# Service Information Letter

Units Affected: AC18, AC23, AC26, AC28, AC40, and AC45 Cranes (see attached list)

## Rotation Fastener Torque Placard Replacement

**Figure 1 — Torque Placard**

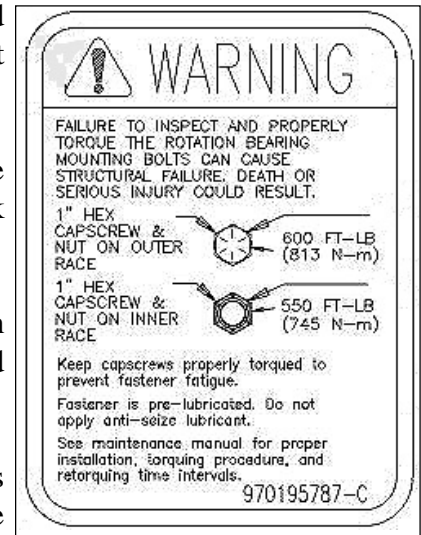
Altec has discovered that a placard was installed on some cranes which has the incorrect torque for bolts used to attach the rotation bearing. This placard has torque values that do not agree with the values in the maintenance manual. This difference can cause rotation bearing fasteners to be insufficiently checked during the periodic torque inspections, possibly leading to accelerated bolt fatigue.

1. Position the unit on a level surface, apply the parking brake and chock the wheels.
2. Inspect the exterior surfaces of the turntable and pedestal above the bed of the crane for an existing torque placard similar to the placard shown in Figure 1. The placard should be nearly identical to the placard on Figure 1, but may have different torque values and bolt sizes.
3. If the placard is not seen on the exterior surfaces, remove valve covers. Look under the valve covers and on the back side of the covers for the placard.
4. If a placard is found, see if the torque values and bolt sizes on the placard are the same as shown in the unit Maintenance and Parts Manual.
5. If a placard torque values and bolt sizes agree with the values in the maintenance manual, the placard is correct and the inspection is complete. Go to Step 7.

Altec requires that the affected units be inspected for the correct rotation fastener torque placard. The placard is located on the outside of the pedestal or turntable. If the placard is missing or not correct, use the list below to select and order the correct placard by calling 1-877-GO ALTEC (1-877-462-5832). Complete the inspection form at the end of this SIL and return it to Altec.

When the replacement placard is received, remove the original incorrect placard and replace it with the new one.

6. If no placard or an incorrect placard (values do not agree with maintenance manual) is found, order the correct kit for the unit model from the list on Page 1.
7. After the inspection is completed, install any covers that were removed.
8. Return the unit to service.
9. Complete the inspection form at the end of this SIL and return it to Altec.
